**REVISED COMPREHENSIVE GLOBAL STABILITY STUDY WORK PLAN
CHIQUITA CANYON LANDFILL
CASTAIC, CALIFORNIA**

This Revised Comprehensive Global Stability Study Work Plan (Revised Work Plan) was prepared by Geo-Logic Associates, Inc. (GLA) to address the February 23, 2026 Department of Toxic Substances Control (DTSC) comments on the December 17, 2025 Comprehensive Global Stability Work Plan (Work Plan). The Revised Work Plan also addresses Work Plan comments from the California Department of Resources Recycling and Recovery (CalRecycle) and the County of Los Angeles Department of Public Health, acting as the Local Enforcement Agency (LEA).

Attachment 1
INFORMATION TO ADDRESS DTSC, CALRECYCLE, AND LEA
COMPREHENSIVE STABILITY WORK PLAN REVIEW COMMENTS
Chiquita Canyon Landfill

FIGURE 4

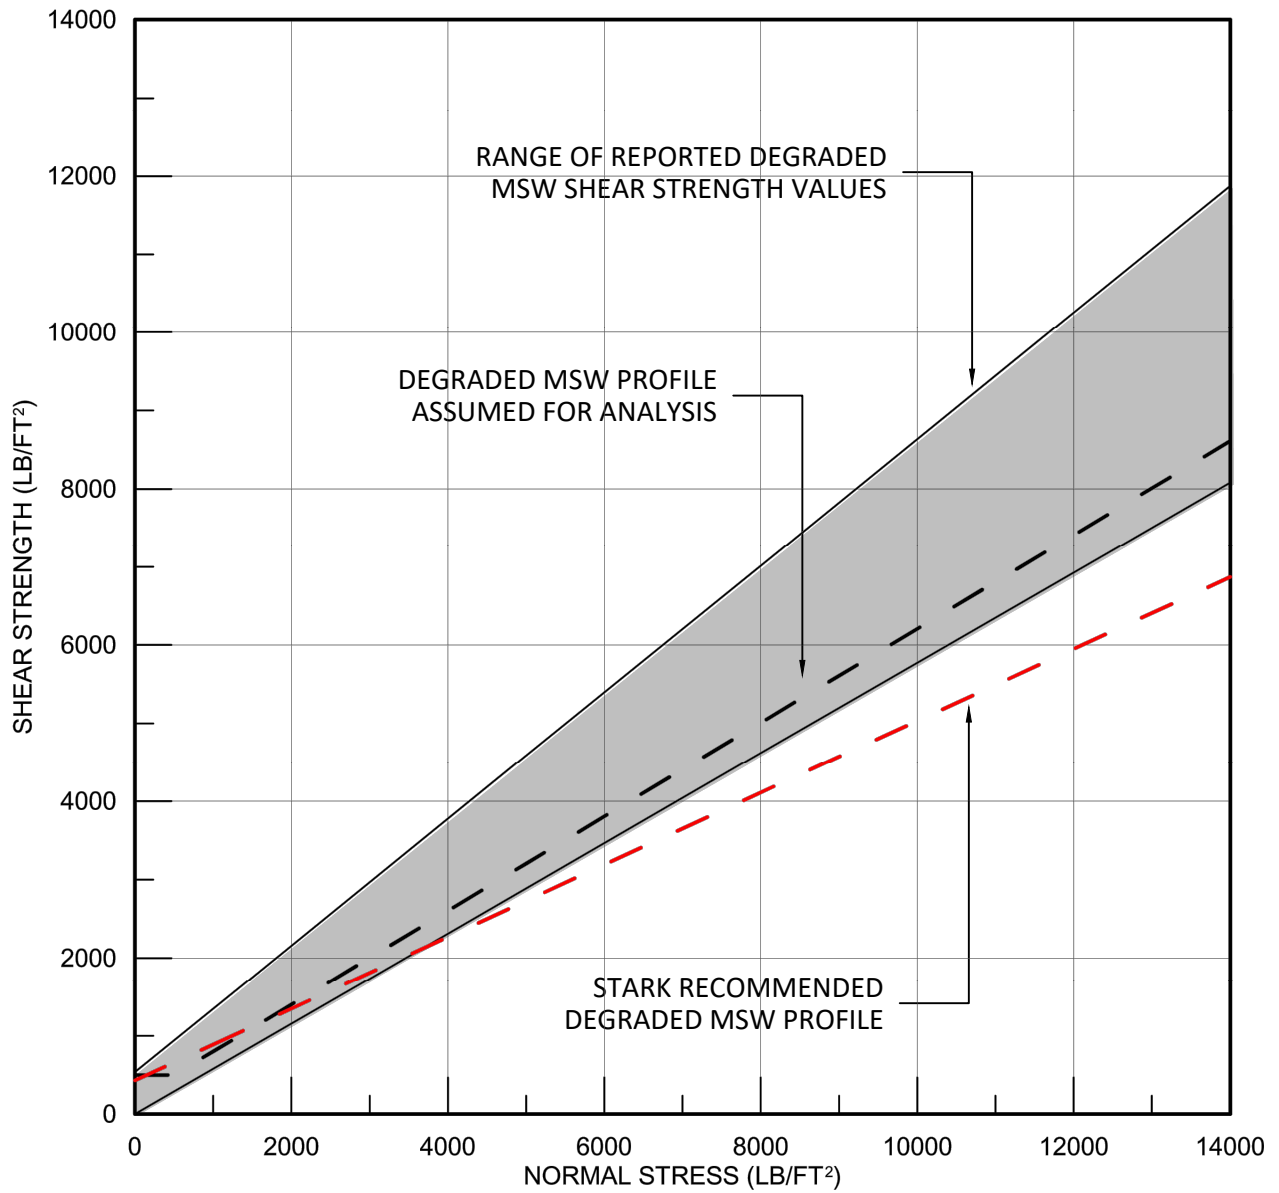
1. Estimate Reduced Shear Strength of Municipal Solid Waste (MSW) due to SET Event: Include estimated Post-SET MSW shear strength properties for analysis profiles slices that intersect areas of documented SET effects at high temperature. Respondents shall provide MSW shear strength parameters that are representative of conditions near the end of/following an SET event from either (1) site-specific MSW sampling and shear strength testing from CCL; (2) technical references; or (3) other proposed parameters approved by DTSC.

Prior to the December GLA (2024e) report, the shear strength of degraded municipal solid waste (MSW) was based on published literature values. The December GLA report incorporated degraded MSW shear strength parameters explicitly recommended by Dr. Timothy Stark. Dr. Stark was retained by the regulatory agencies as their technical expert, and his recommendations regarding degraded MSW shear strength parameters were therefore incorporated into the analyses. Figure 4 from the December GLA report is included with this attachment and illustrates both the degraded MSW profile assumed in the earlier GLA analyses (GLA 2024a, 2024b, 2024c, and 2024d) and the Stark-recommended degraded MSW profile used in the December analyses. Use of the Dr. Stark-recommended profile was identified in the original Work Plan and is retained in the Revised Work Plan. GLA therefore assumes that DTSC accepts these parameters for use in the analyses.
